UNITED STATES PATENT AND TRADEMARK OFFICE

Office Action Summary	Application No. 10/525,430	Applicant(s) CLAUSS, CHRISTIAN	
	Examiner Krishnan S. Menon	Art Unit 1797

DETAILED ACTION

FIG. 5

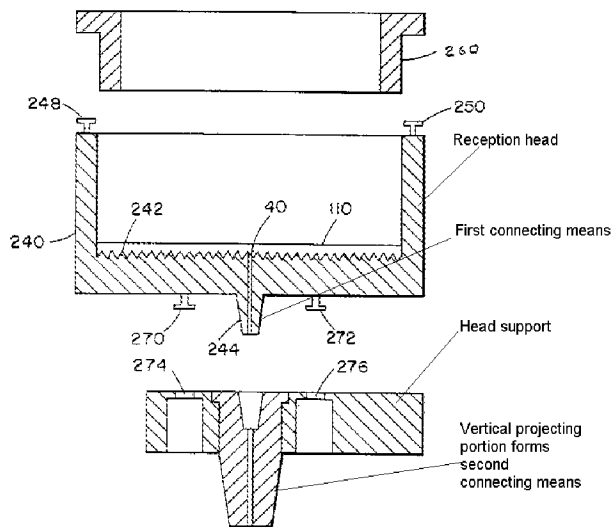
Claims 4-6: figure 5 of Johnson reads on claims 4-6: 240 can be the reception head that receives a filter over 242; the mating part below 240 is the head support. Keying means – 270-274, 272-276. See the figure below:

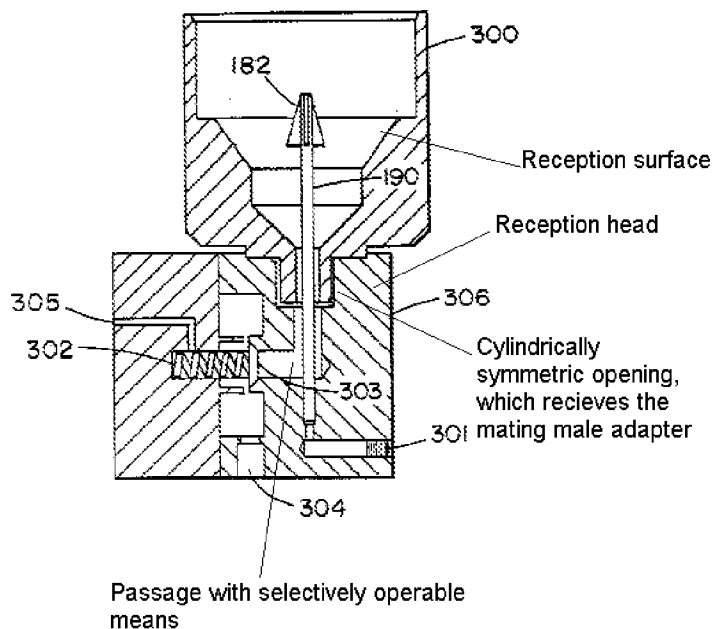
The elements recited in claim 11 can be found in figs 6 and 7A of Johnson, except for the transverse bore and the key. The newly added limitation in claim 1 recites only a valve that functions by a translatory movement in the bore or the passage, which is how a ball-check valve works. See the limitations of claim 11 with respect to the relevant portion of figure 6 presented below:

The missing element is the transverse bore to accommodate a locking key that is intended for locking the male portion of the mating part in the opening. However, this kind of key locks are well known in the art, such as set screws, etc., and is not a patentable limitation, unless applicant can show otherwise.
